Access Compliance Report

Public Rights-of-Way

(Curb Ramps)

Intersection ID: 8439	Main Street: TILLMAN_RD	Cross Street: WELLING_AV	Location: W
ADA ID: 3204FC3CE1EA	Ramp Type: Perp	Initial Pass/Fail: Fail	Overall Compliance: No
Severity Score: 10			
Codes/Mitigation Info/Possible Solution		Field Measurements/Component Compliance

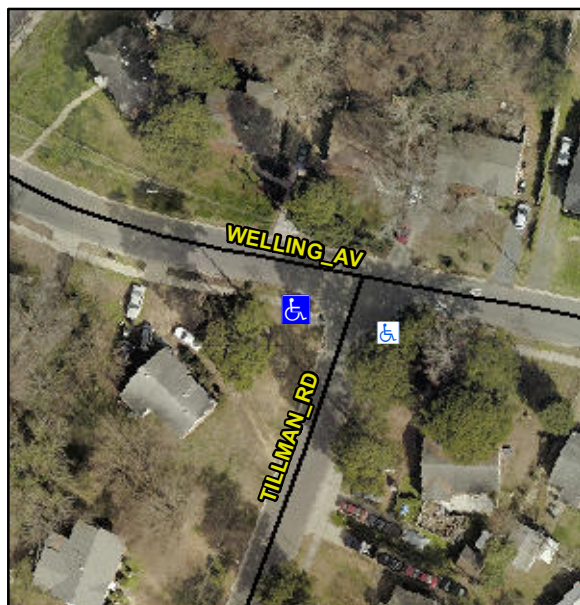
Not Found, R304.5.1, R304.5.3

Compliance	Description	Data	Compliance	Description	Data
N/A	Ramp Length (in)	50.5	Yes	Ramp Slope (%)	7.0
No	Ramp Width (in)	47.0	No	Ramp XSlope (%)	3.5
N/A	Flare Type LT	N/A	N/A	Flare Type RT	N/A
N/A	Flare Slope LT (%)	N/A	N/A	Flare Slope RT (%)	N/A
N/A	Flare Traversable LT?	N/A	N/A	Flare Traversable RT?	N/A
N/A	Landing Length (in)	N/A	N/A	DWS Provided?	N/A
N/A	Landing Width (in)	N/A	N/A	DWS Contrast?	N/A
N/A	Landing Slope (%)	N/A	N/A	DWS Length (in)	N/A
N/A	Landing X Slope (%)	N/A	N/A	DWS Full Width?	N/A
N/A	Landing Curb? (Y/N)	N/A	N/A	DWS Offset (in)	N/A
N/A	Shared Landing?	N/A			
N/A	Gutter Ponding?	N/A	N/A	Gutter Slope (%)	N/A
N/A	Gutter Lip Ht (in)	N/A	N/A	Gutter X Slope (%)	N/A
N/A	Painted X Walk1?	No	N/A	Painted X Walk2?	N/A
	X Walk 1 Direction	To SE		X Walk 2 Direction	N/A
N/A	X Walk 1 Width (in)	N/A	N/A	X Walk 2 Width (in)	N/A
	X Walk 1 Slope (%)	2.7		X Walk 2 Slope (%)	N/A
	X Walk 1 X Slope (%)	3.0		X Walk 2 X Slope (%)	N/A

Remove & Replace Entire Ramp.
